# Randwick Local Planning Panel (Public) Meeting

## Development Application Report No. D69/25

**Subject: 8 Clyde Street, RANDWICK (DA/222/2020/A)**

<b>Proposal:</b>	Section 4.56 - Modification to the Court approved consent including reduction in the number of parking spaces to 3 including 2 car share spaces, building envelope modifications including the lift core and fire staircase, internal reconfiguration, increase in floor-to-floor heights, addition and changes to balconies, changes to waste arrangements, landscaping amendments, and other associated works.
<b>Ward:</b>	East Ward
<b>Applicant:</b>	Cadele Investments Pty Ltd
<b>Owner:</b>	Cadele Investments Pty Ltd
<b>Cost of works:</b>	\$8,195,776.00
<b>Reason for referral:</b>	The modification application is made under section 4.56 of the <i>Environmental Planning and Assessment Act 1979</i> and seventeen (17) unique submissions by way of objection were received by Council.

**Figure 15:** Proposed ground floor plan (Source: *TonkinZulaikhaGreer*)

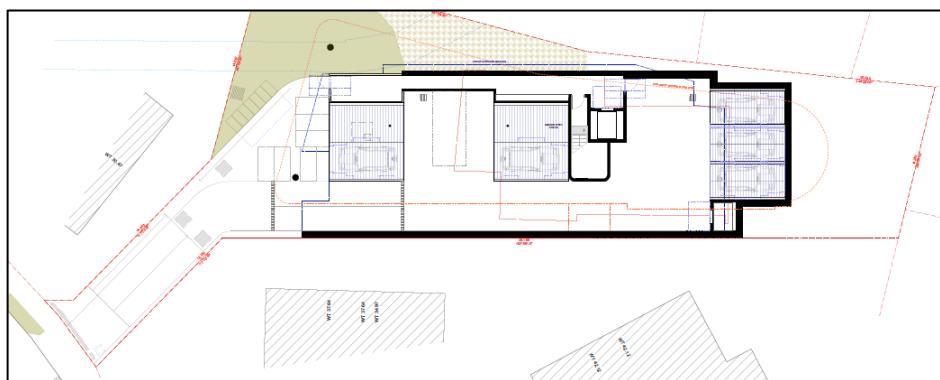
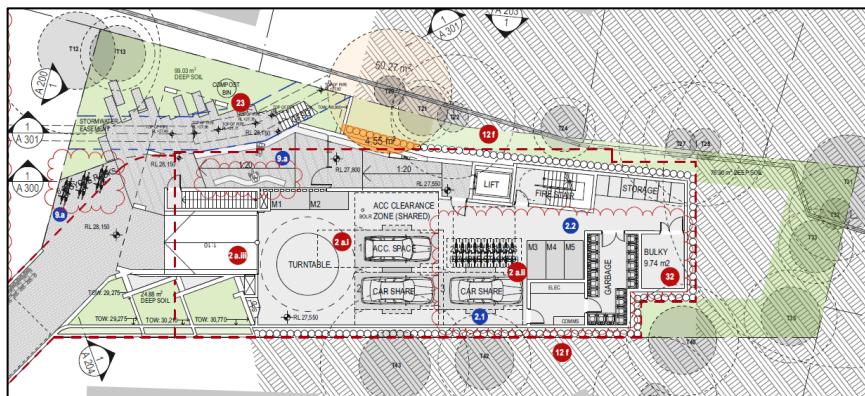
However, the number of parking spaces has been reduced from 11x spaces (including 1x carshare) to 3x spaces (including 2x carshare), which represents a significant reduction in parking for the same number of occupants. As such, Council is not satisfied that the modification application demonstrates consistency with the substantially the same development test and is therefore recommended for refusal.

The amended modification application seeks to provide 3x vehicle parking spaces, 2x of which are carshare spaces and 1x accessible parking space (equivalent to 11x spaces).

Figure 18: Proposed fourth floor plan (Source: TonkinZulaikhaGreer)

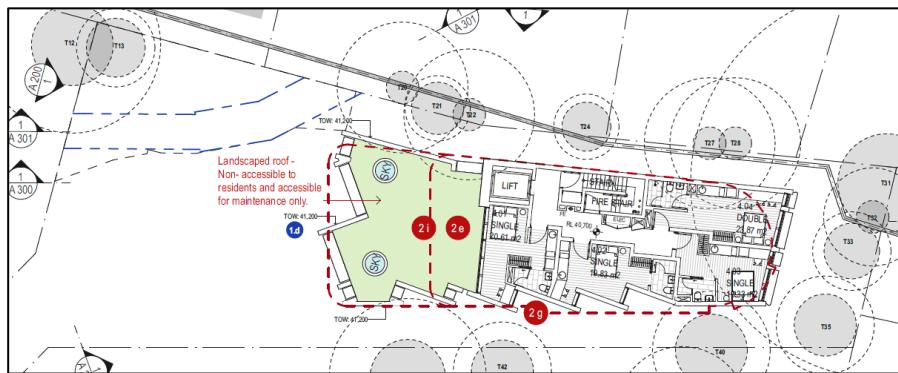
Should the modification application have been supported, Council would support deleting this condition as the envelope of the southern side of level 4 is consistent with the requirement for the deletion of Room 4.01 in the development application.

- The building height and view impacts were considered acceptable by the Court, subject to the deletion of Room 4.01 (paragraph 176). The proposed changes to the building envelope including additional building height within the existing view corridor has not been adequately considered by the applicant who has failed to provide a detailed view analysis. As such, the applicant has failed to consider whether the view impacts are acceptable based on the amended modification application and fails to consider that the development was supported by the Court in part for achieving sufficient view sharing considerations.

Figure 20: Proposed eastern elevation (Source: TonkinZulaikhaGreer)

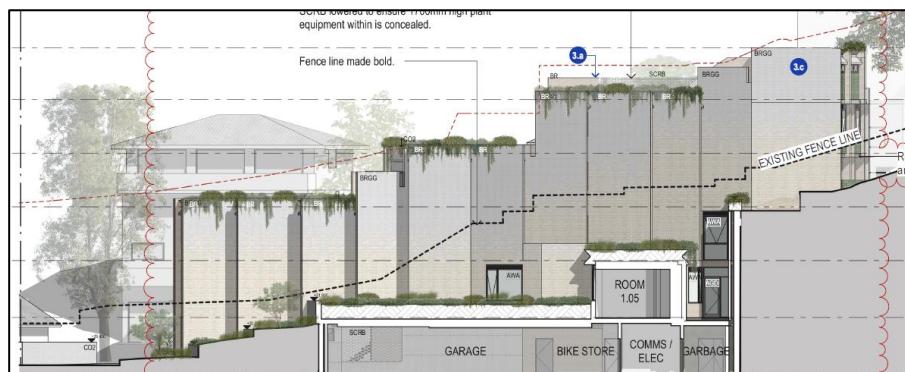
The glazing facing east has been modified to minimise overlooking to neighbours as well as maximising internal amenity of rooms. All windows on the eastern elevation have been angled to face south or north so as not to impact on the privacy of the private open space of 4-6 Clyde Street. Glazing facing east and north-east to the manager's room has been deleted.

Should the modification application have been supported, Council would required this condition to continue to be imposed to northern windows to ensure adequate privacy is maintained to northern adjoining neighbours.

**Figure 26:** Proposed POS under the subject amended modification application (Source: SHED)

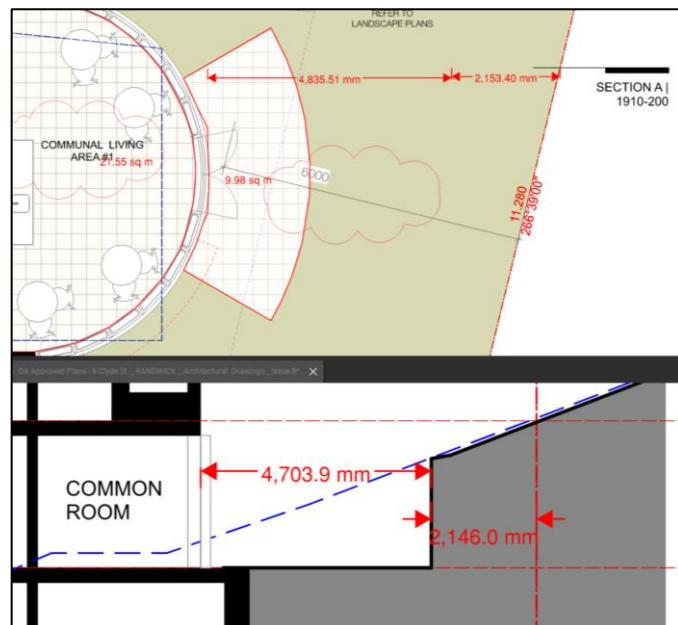
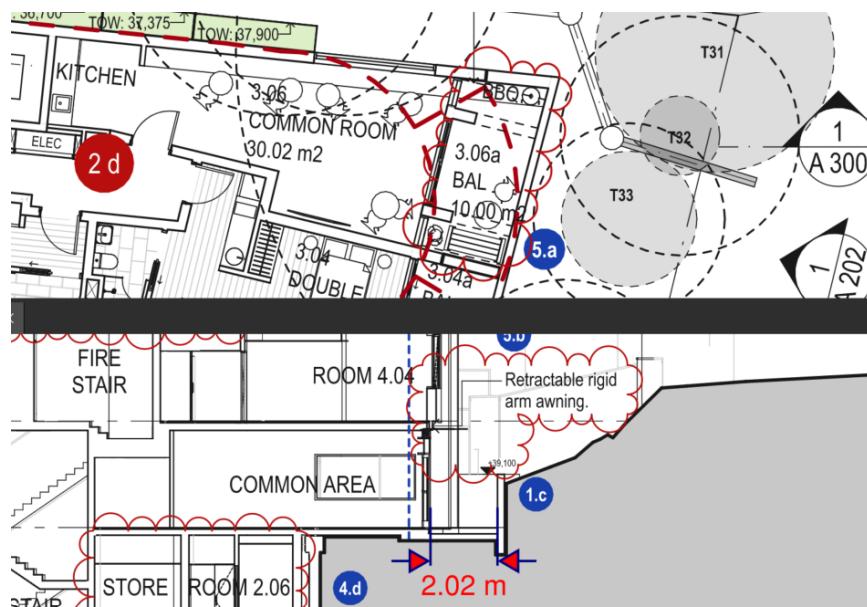
The development consent granted by the Court included a boarding house with a POS of >20sqm. This was facilitated in a similar arrangement proposed under the amended modification application at the level 3, however a greater area was to be excavated to provide an area that provided sufficient amenity. Whilst this is not clear on the Level 3 plan, the elevations and sections show an area with a depth of 4-4.7m and a retaining located closer towards the northern boundary. Figure 25 below shows this area as approved in the development application:

The amended modification application seeks consent to provide a POS area of 10m<sup>2</sup> as a sunken balcony adjoining the main CLA, with a BBQ, seated area and a retractable awning above. The 10m<sup>2</sup> area is a variation of 10m<sup>2</sup> with this POS development standard in the ARH SEPP. See Figure 26 below.

Figure 5: North elevational shadow diagrams for 9 Mount Street, Coogee

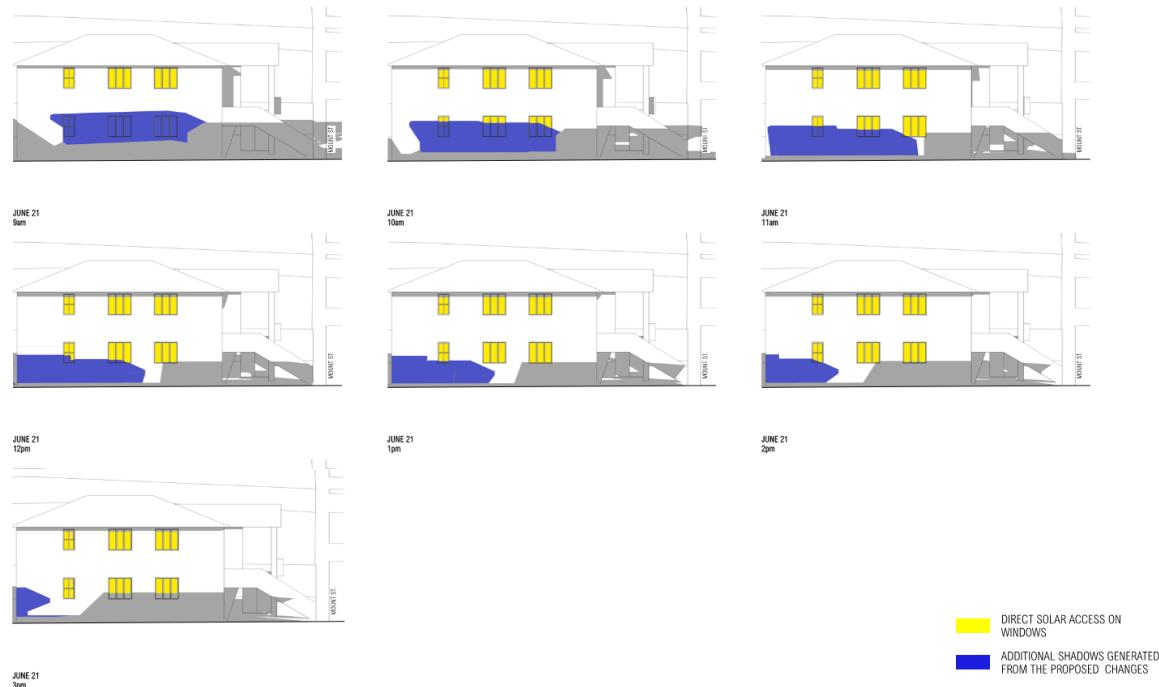
This modification will:

- Reduce perceived dominance and visual bulk along the shared boundary.
- Improve daylight penetration to the subject site's private open space and north-facing windows of No. 9 Mount Street.
- Align the proposal more closely with the intent of the DCP rear setback and solar access provisions.

Figure 6: Existing and Proposed Shadow Diagrams on 21 June

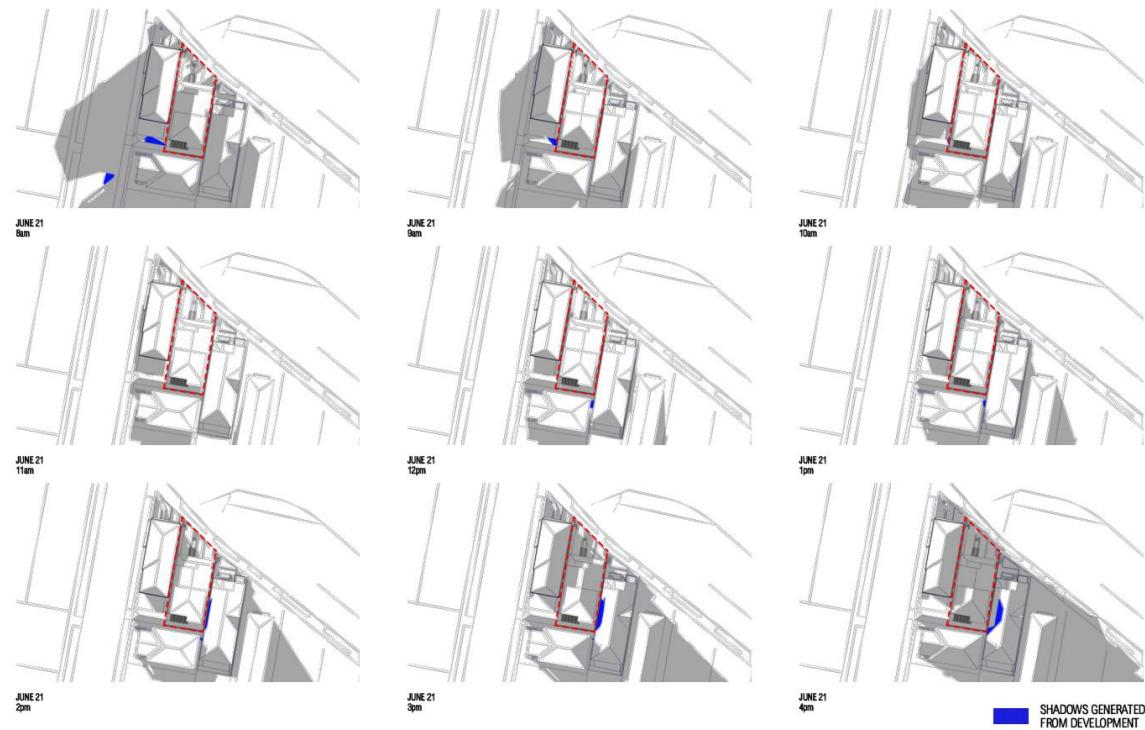
- Shadow diagrams indicate that most north-facing windows are already overshadowed by existing development during midday and will not be further impacted by the proposed works.
- Morning solar access between 8:00am and 10:00am is retained and unaffected by the proposal, as the first-floor addition is well setback from the front boundary.

Accordingly, the proposal does not reduce existing solar access to these windows during the critical morning period and is considered to satisfy the relevant DCP control.
